REVISED
City of Mission
Regular Meeting Agenda
Wednesday, February 21, 2018
7:00 p.m.
Mission City Hall

RE: Martway Mixed Use development Preliminary Site Plan, 6005-6045 Martway Street

STAFF REPORT
Planning Commission Meeting September 25, 2017
Updated for December 18, 2017

REQUEST: Preliminary Site Development Plan for Martway Mixed Use Development

EXISTING FLOOD PLAIN PLAN

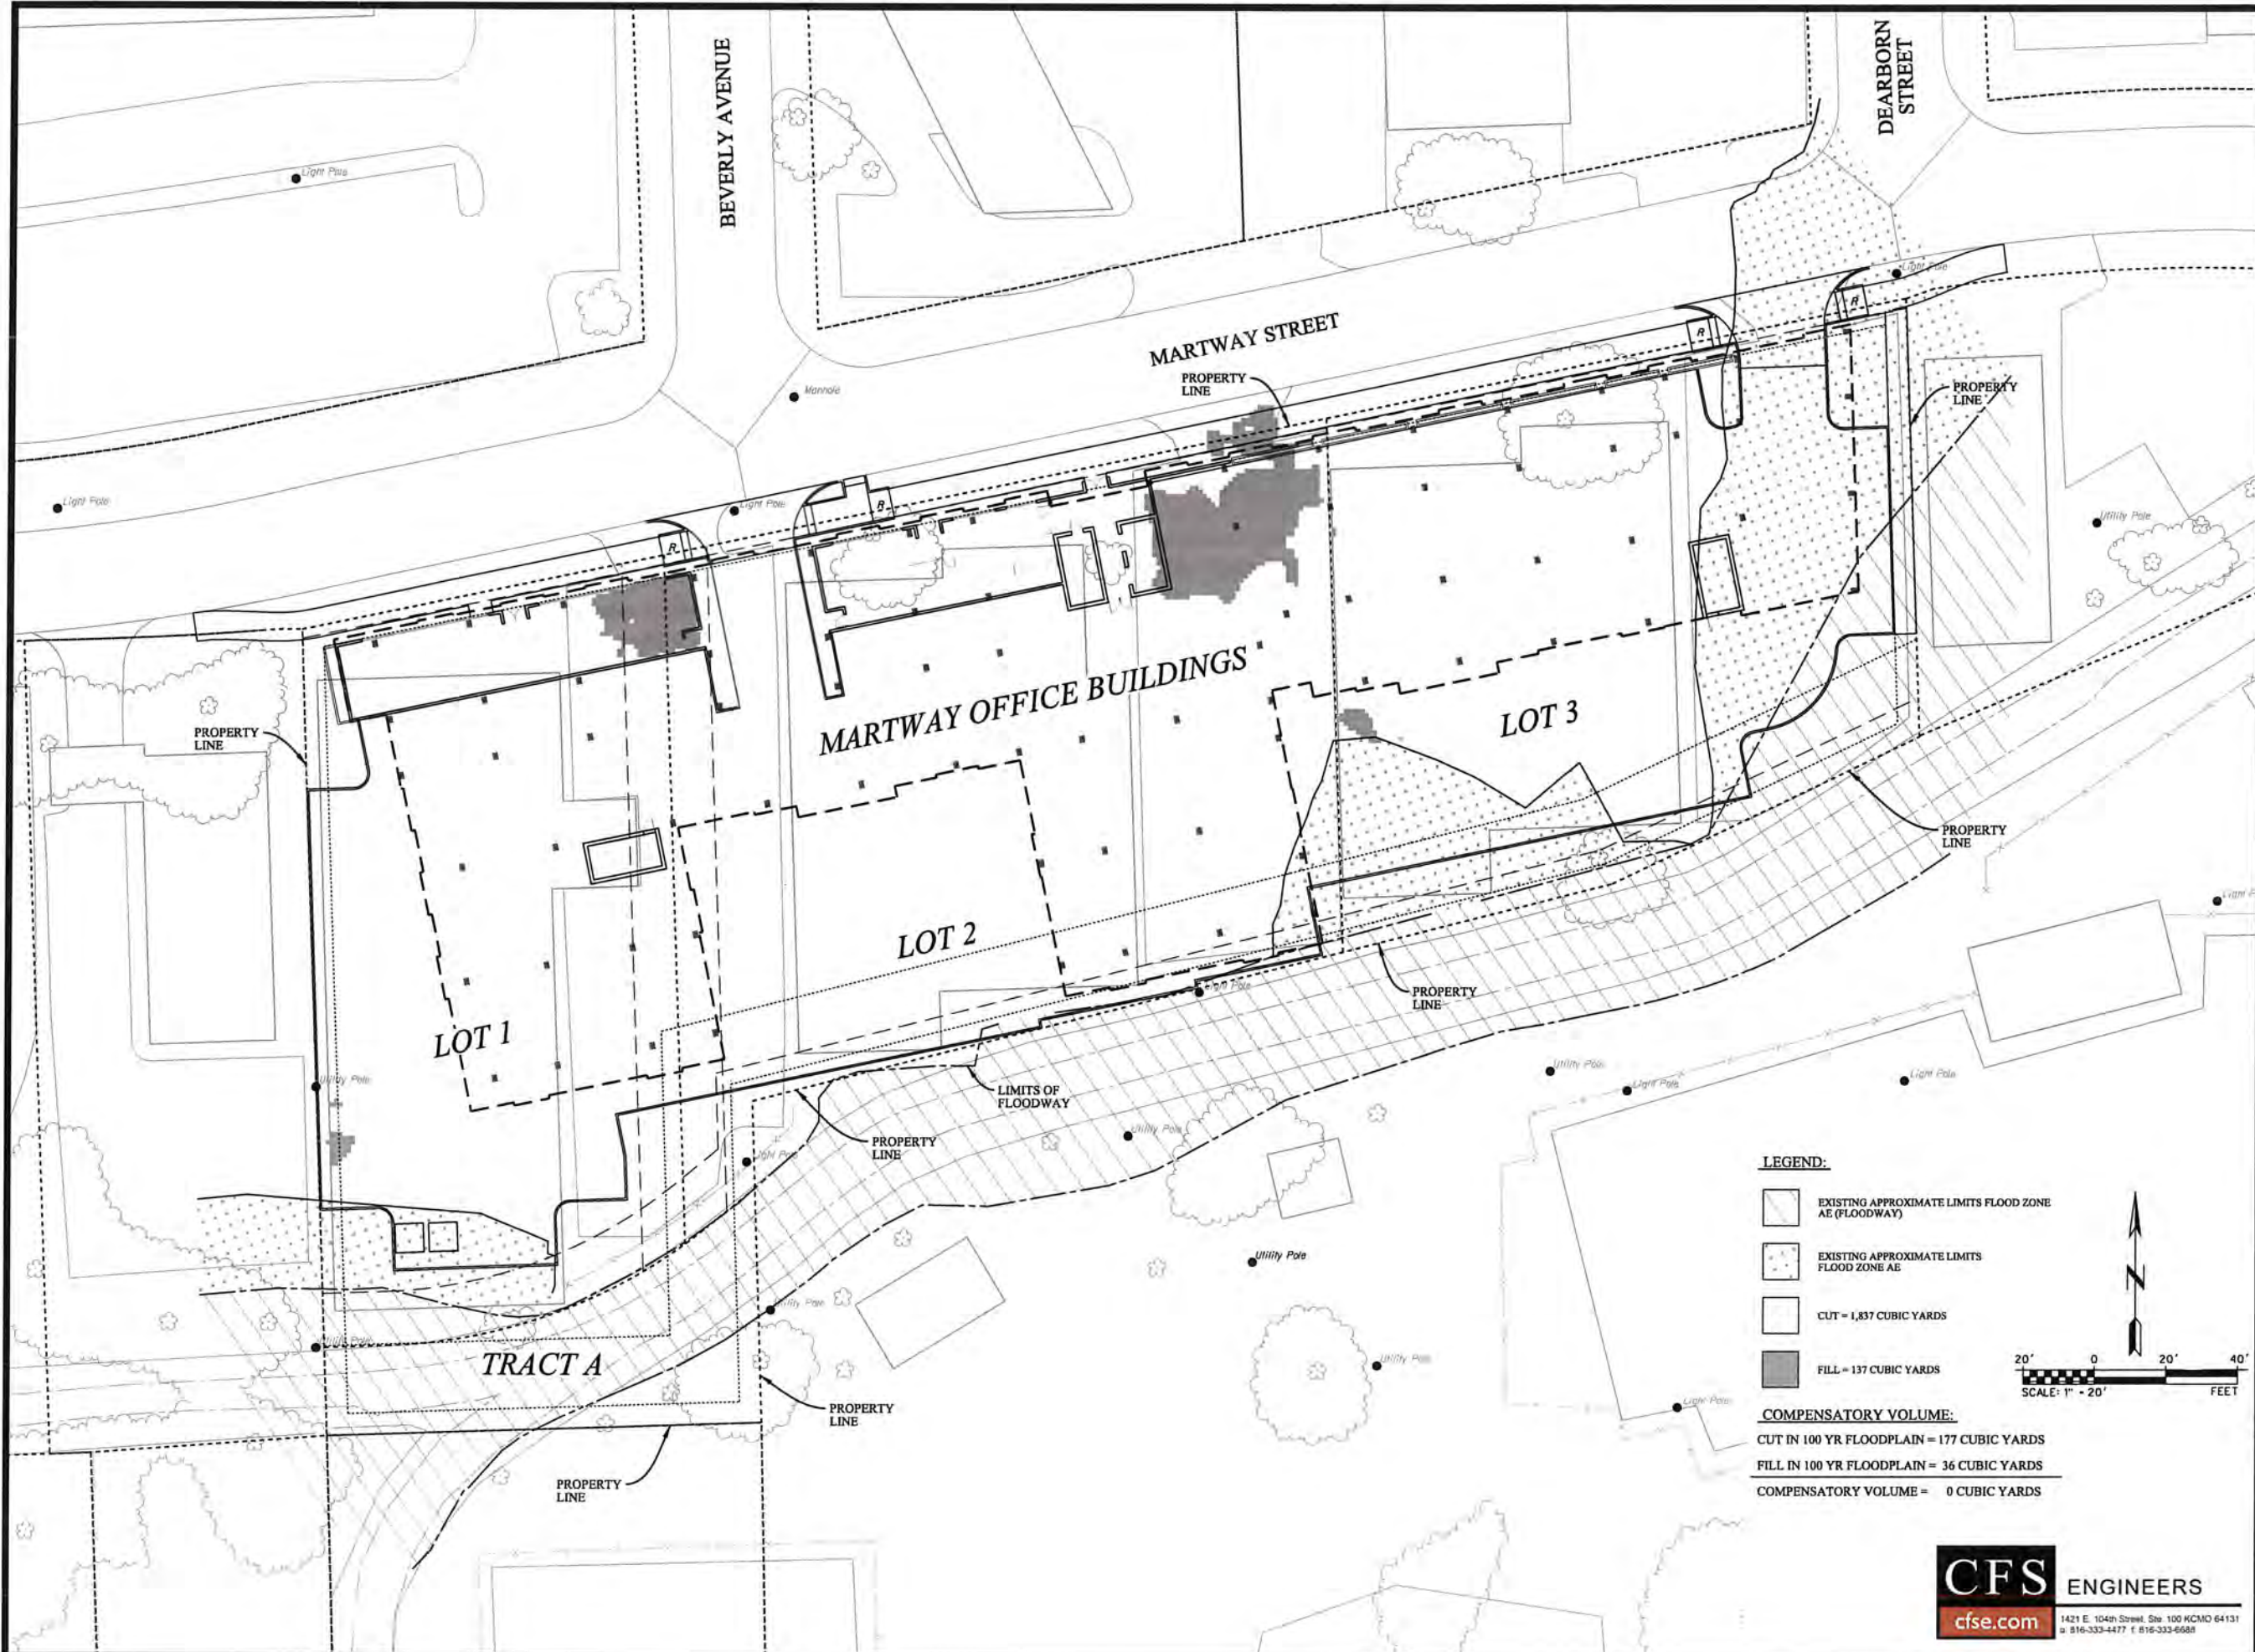
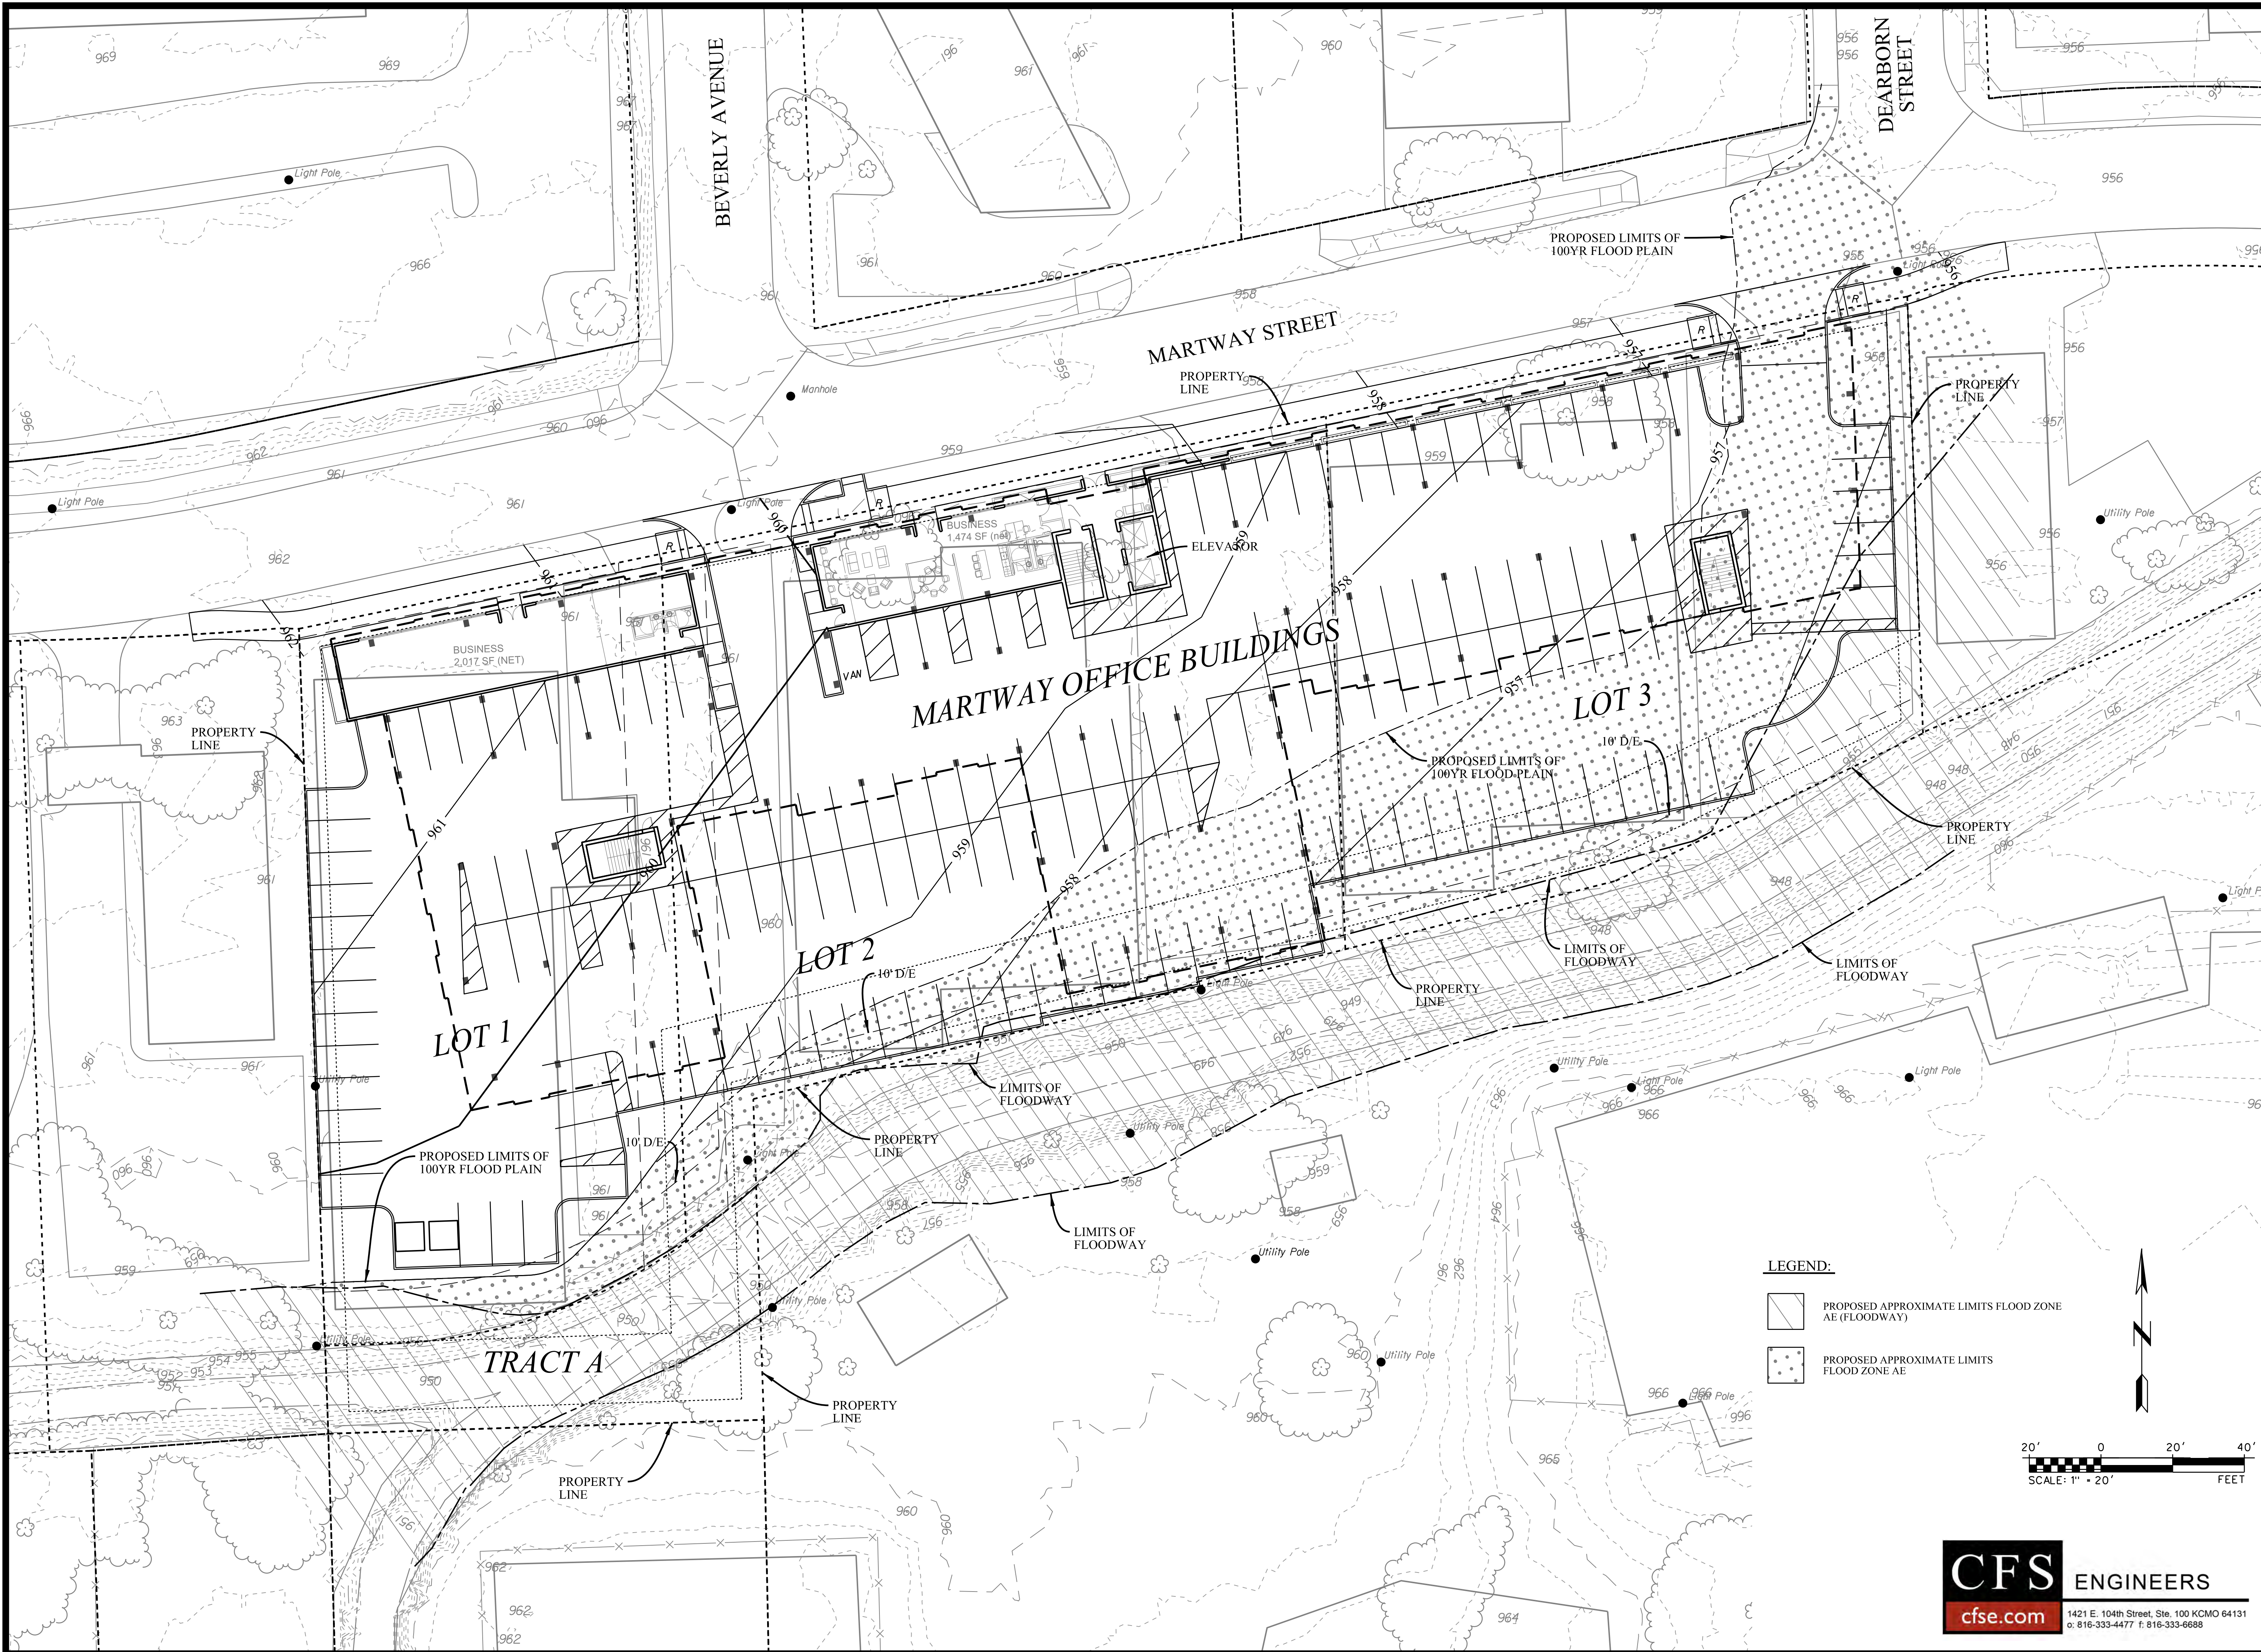
Both the traffic study and the drainage memo has been updated to address parking lot ponding. The 100 year floodplain limits over parking lot have been shown on Sheet C-203, Proposed Floodplain Plan. The parking lot has been graded such that no parking stall would pond over 7" based on the FEMA floodplain depths.

The 100 year floodplain limits over parking lot have been shown on Sheet C-203, Proposed Floodplain Plan. The parking lot has been graded such that no parking stall would pond over 7” based on the FEMA floodplain depths.

Sheet C100

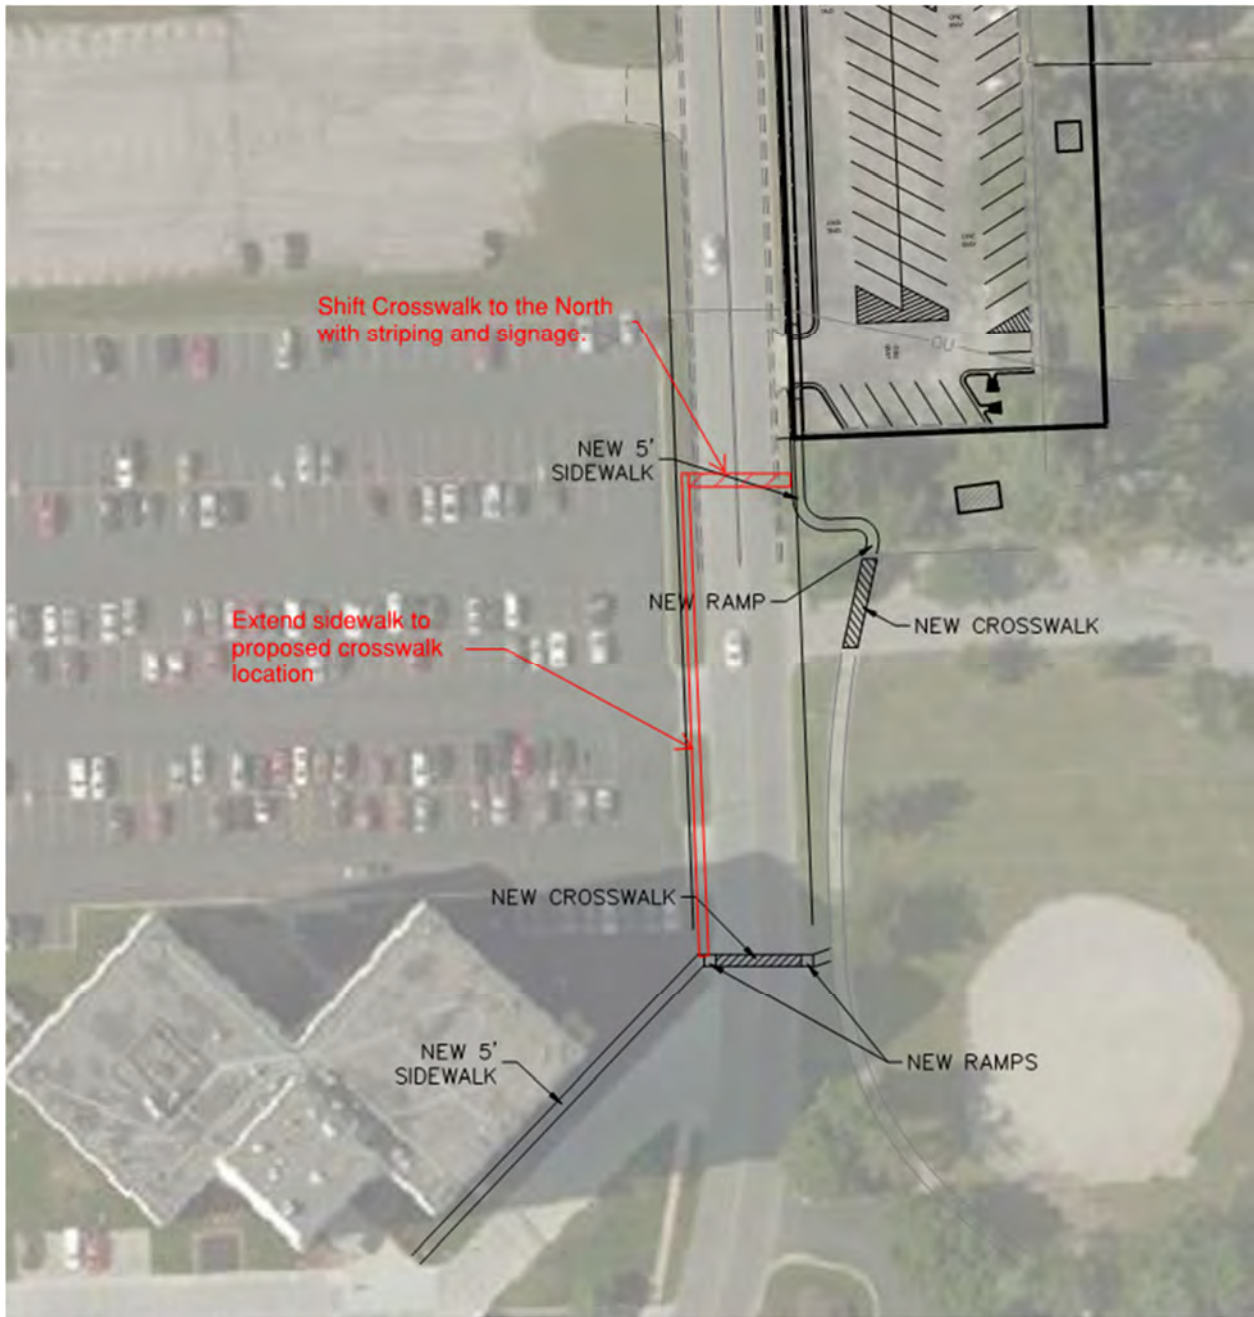
- The current crosswalk location (crossing Broadmoor St) is close to multiple drives which may conflict with crossing pedestrians.
 - Applicant should consider shifting north to be further from these driveways and be closer to the new parking lot and park entrance. (see attachment for possible schematic)
- Crosswalk location shall have Pedestrian Crossing Warning Signs with flashing beacons installed for both directions of travel. Signs shall have pushbuttons to activate beacons. Advanced warning signage in both directions further upstream may also be required depending on final crosswalk location.
- Crosswalk striping shall be installed per APWA standards.
